Project	IEEE 802.16 Broadband Wireless Access Working Group < http://ieee802.org/16 >	
Title	PMK Refresh	
Date Submitted	2005-07-18	
Source(s)	Simon Mizikovsky, Robert Rance, Peretz Feder Lucent Technologies	Voice: 973-386-6348 Fax: 973-386-4555 mailto:smizikovsky@lucent.com
Re:	Call for contribution and comments.	
Abstract	A method for refreshing the PMK (Pairwise Master Key) without re-contacting the AAA-Server.	
Purpose	Adoption	
Notice	This document has been prepared to assist IEEE 802.16. It is offered as a basis for discussion and is not binding on the contributing individual(s) or organization(s). The material in this document is subject to change in form and content after further study. The contributor(s) reserve(s) the right to add, amend or withdraw material contained herein.	
Release	The contributor grants a free, irrevocable license to the IEEE to incorporate material contained in this contribution, and any modifications thereof, in the creation of an IEEE Standards publication; to copyright in the IEEE's name any IEEE Standards publication even though it may include portions of this contribution; and at the IEEE's sole discretion to permit others to reproduce in whole

Figure 1 – PMK Refresh Protocol

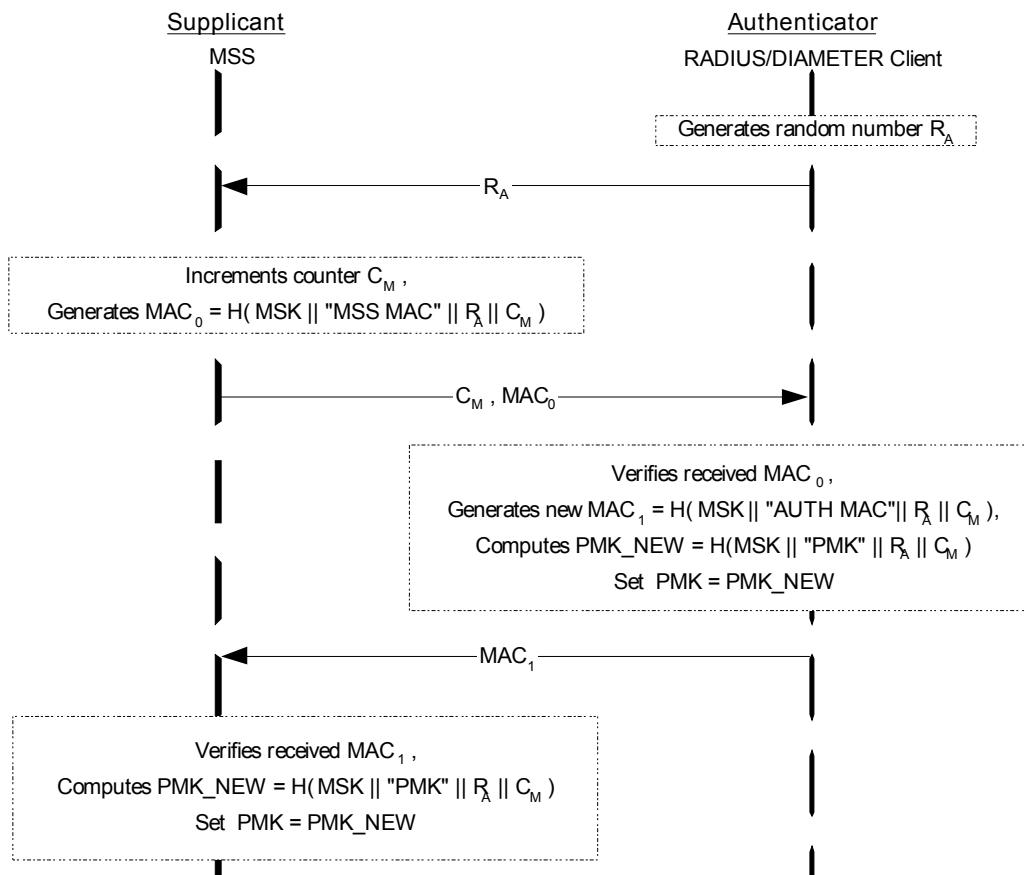
[Modify the corresponding sections as follows: Insert new subsection 14.5.5.2.1]

14.5.5.2.1 PMK Refreshing

After initial establishment, the PMK may be periodically refreshed by executing the PMK Refresh procedure between the Authenticator and the MSS. The procedure is shown on Figure 1 below and is defined as follows:

The initial PMK generated at the completion of the EAP Access Authentication is defined as $SHA(MSK || \text{"PMK"})$.

In the figure above, $H(\)$ denotes HMAC-SHA 160(), the symbol \parallel means concatenation, and value “...” denotes the string.

The protocol is initiated by the Serving Network. In the first message, the network sends the 64-bit random challenge R_A to the MSS.

The mobile maintains a local 32-bit access counter, which it increments every time the PMK needs to be refreshed. The counter is reset when the initial PMK is generated at the end of the EAP exchange. The MSS increments the counter C_M , and computes the MAC (Message Authentication Code) of the returned transaction as

$$MAC_0 = H(MSK \parallel \text{“MSS MAC”} \parallel R_A \parallel C_M).$$

The mobile sends the response message to the network containing the C_M and MAC_0 .

The serving network validates the MAC_0 , and then computes its own

$$MAC_1 = H(MSK \parallel \text{“AUTH MAC”} \parallel R_A \parallel C_M).$$

The network also computes the new value of the PMK:

$$PMK_NEW = H(MSK \parallel \text{“PMK”} \parallel R_A \parallel C_M).$$

In the returned message the network sends the MAC_1 to the MSS for validation.

The MSS validates the MAC_1 as an indication of successful completion of the mutually authenticated protocol, and computes the new PMK as shown above.

If the protocol is received uncorrupted, both sides know with cryptographic certainty that they have generated a matching secret key PMK_NEW . At this point the current active value of the PMK is set to the computed PMK_NEW . Otherwise, if the protocol is corrupted in either direction, the corresponding party will detect this and abort the transaction, leaving the current value of the PMK intact.
